NEATH PORT TALBOT COUNTY BOROUGH COUNCIL
LOCAL DEVELOPMENT PLAN (2011-2026)

EXAMINATION IN PUBLIC:
Matter 7: Environment & Resources

Statement of Agreement between Neath Port Talbot CBC and Natural Resources Wales

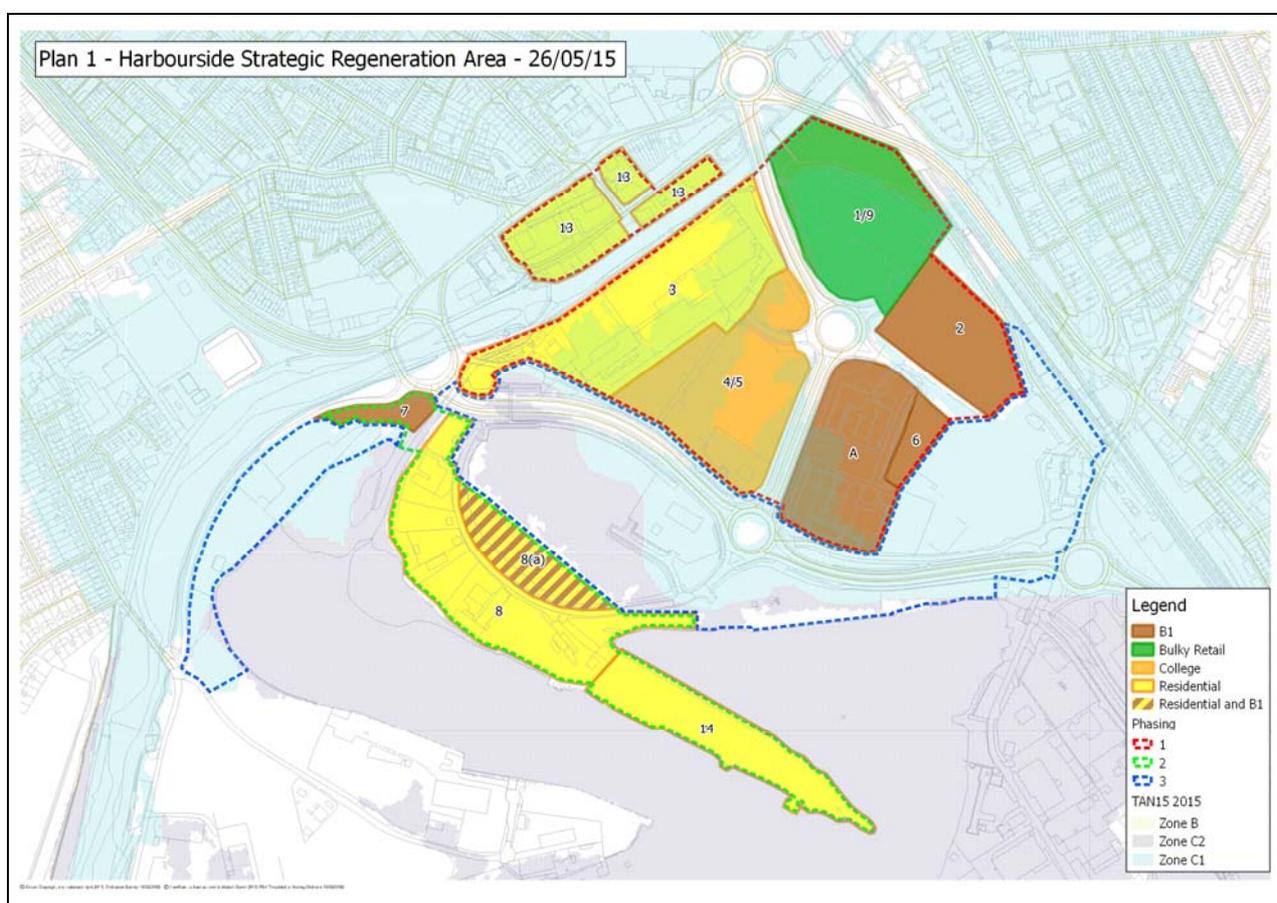
In accordance with the agreement with NRW, the following changes are proposed to the LDP and associated SPG:

- Removal of Plots 11 and 12 from the Harbourside SRA2 allocation;
- Reduction in the Harbourside employment allocation from 11 hectares to 7 hectares;
- Consequential additional 4 hectares added to the Baglan Bay employment allocation;
- Amendment of the SPG Masterplan to take into account the amended allocation boundary and to move Plot 10 from Phase 2 to Phase 3; and
- Other minor changes to site boundaries within the Masterplan.

Plan 1 - Harbourside Strategic Regeneration Area - 26/05/15

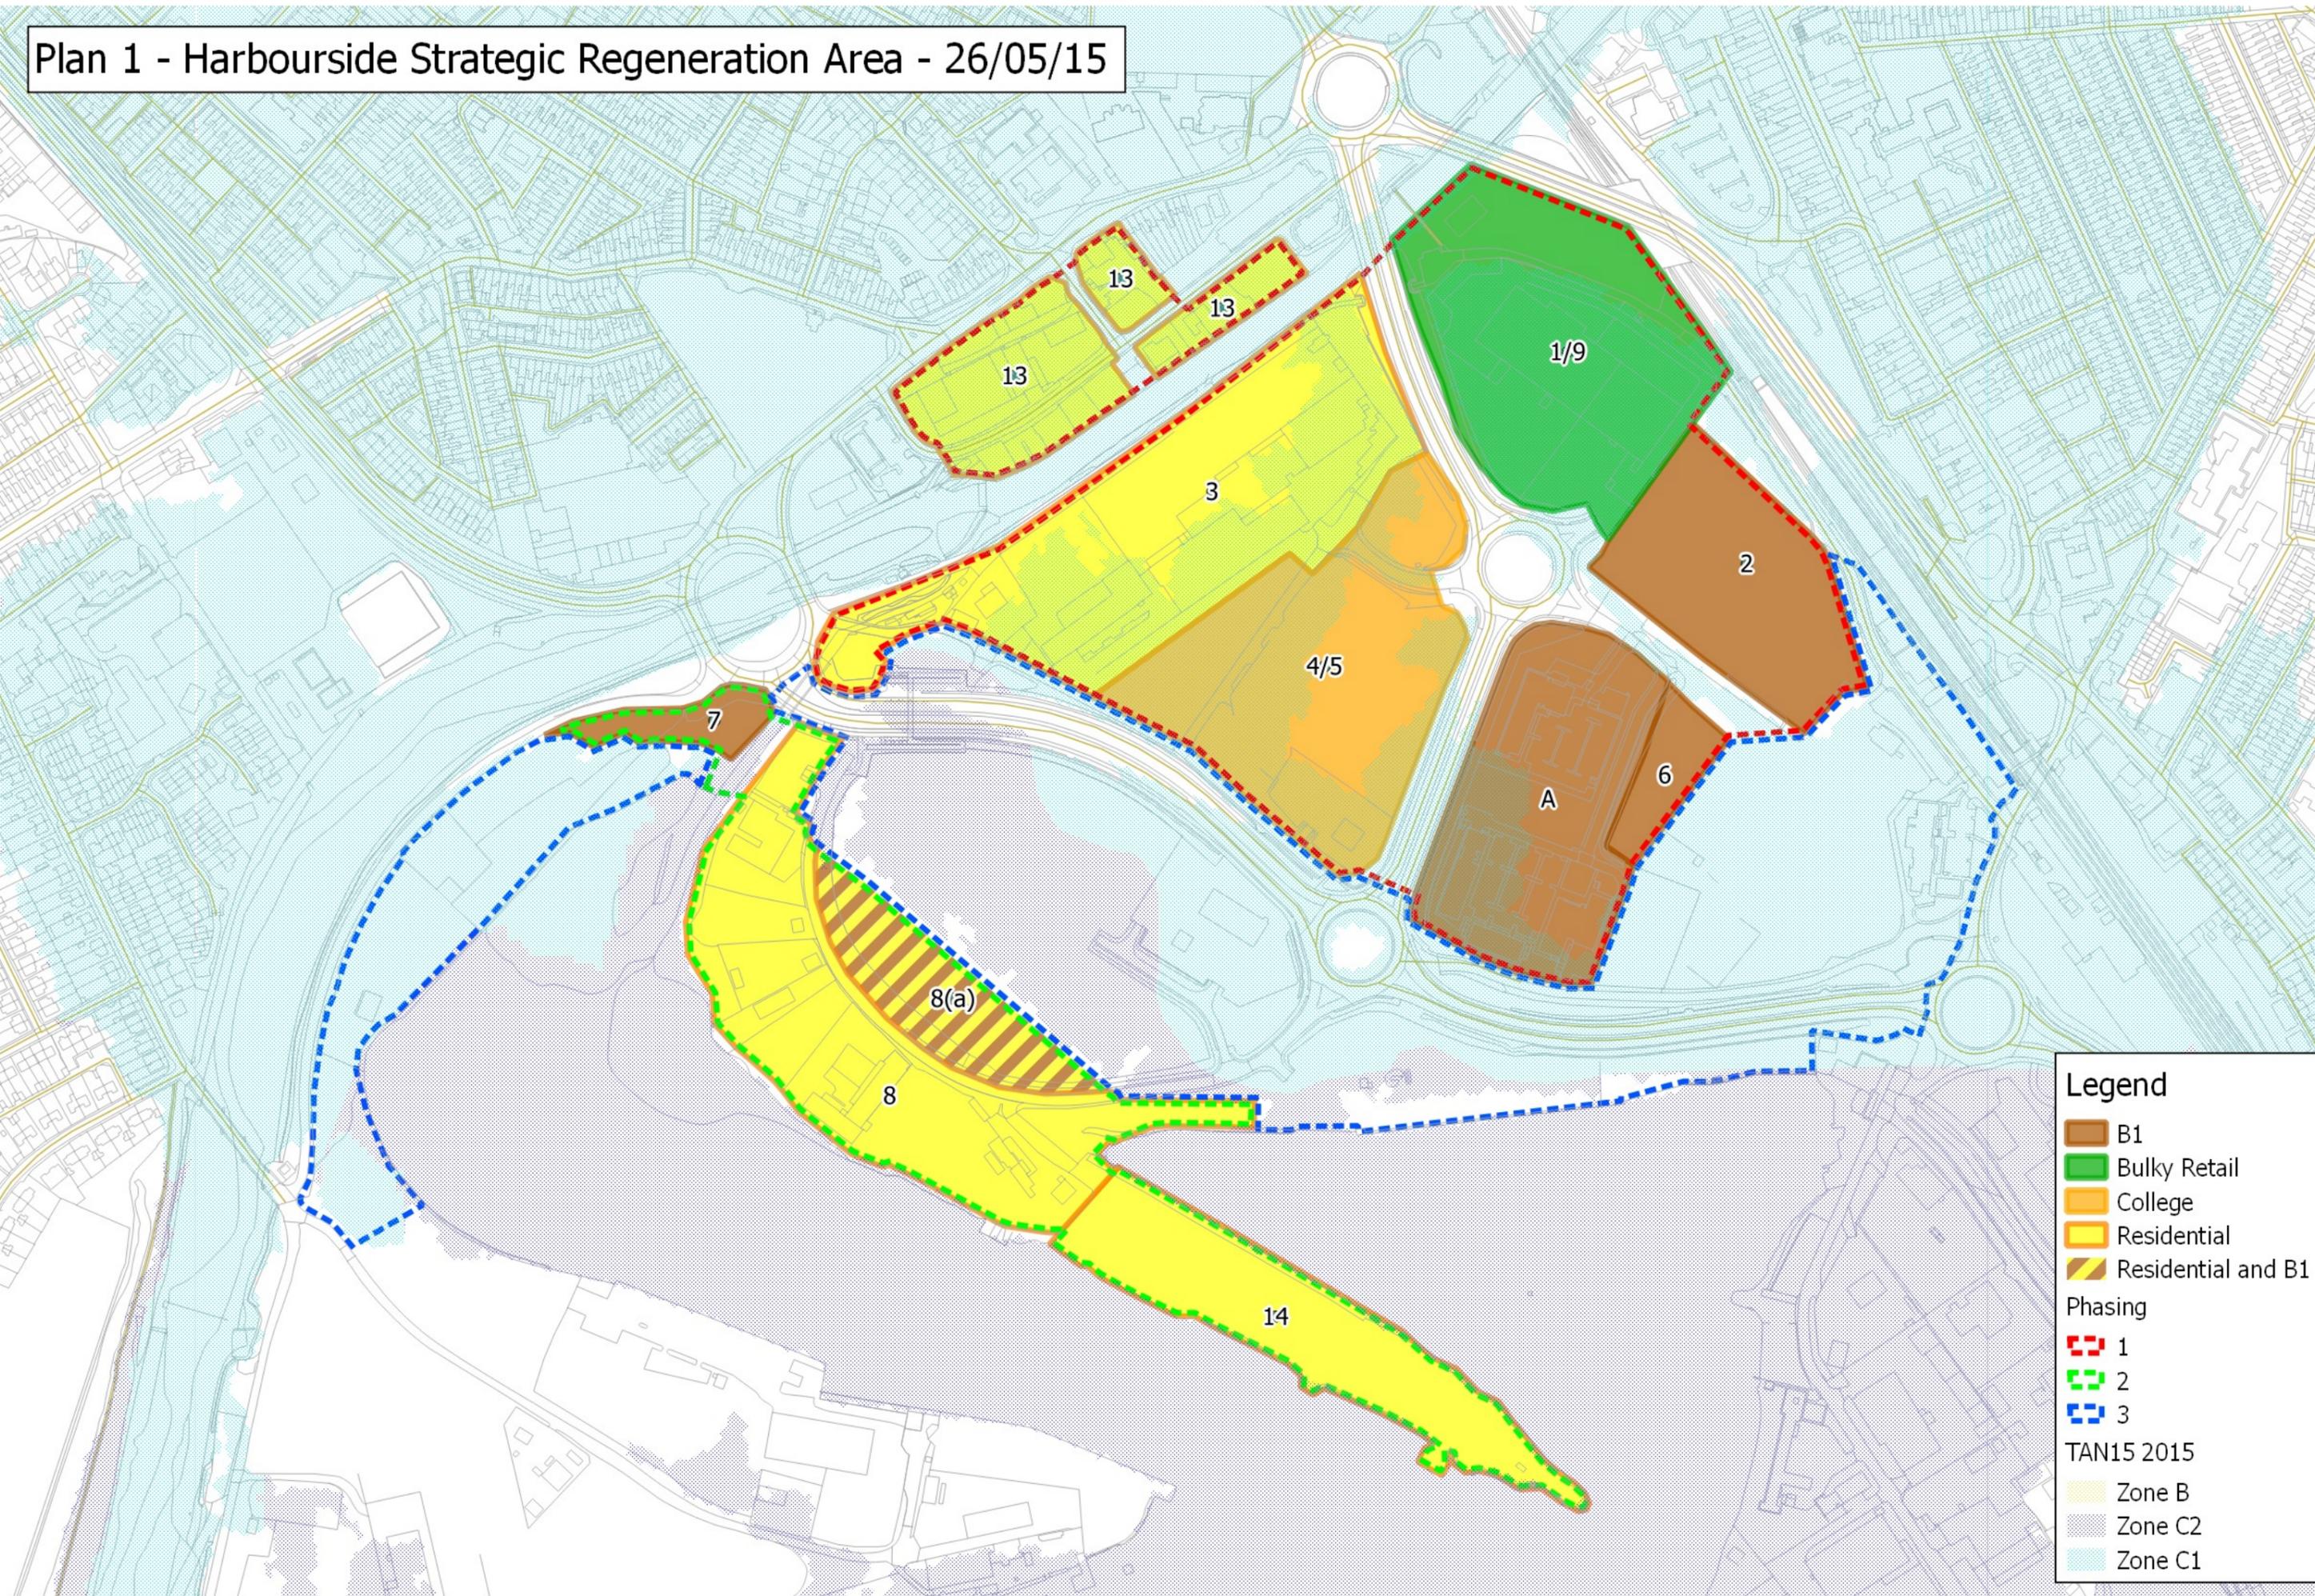
Map 4.2 - replace map with the latest version of the Harbourside SRA Masterplan (dated 26th May 2015).

Delete Plots 11 (Gasworks) and 12 (Henshaw Street) from the SRA2 allocation area.

1. The boundaries of the Harbourside Strategic Regeneration Area (LDP Policy SRA2) are amended to exclude Plot 11 (Gasworks) and Plot 12 (Henshaw Street); and
2. The *draft* Port Talbot Harbourside and Town Centre Development Framework SPG is amended to take into account the above changes and to reconfigure the development plots in accordance with Plan 1 Harbourside Strategic Regeneration Area (dated 26th May 2015)(i.e. delete Plots 11 and 12, reassign Plot 10 to Phase 3, add Plot 14 and designate part of Plot 8 as mixed employment / residential use).

Map 4.2 - insert revised Harbourside Masterplan as appended.
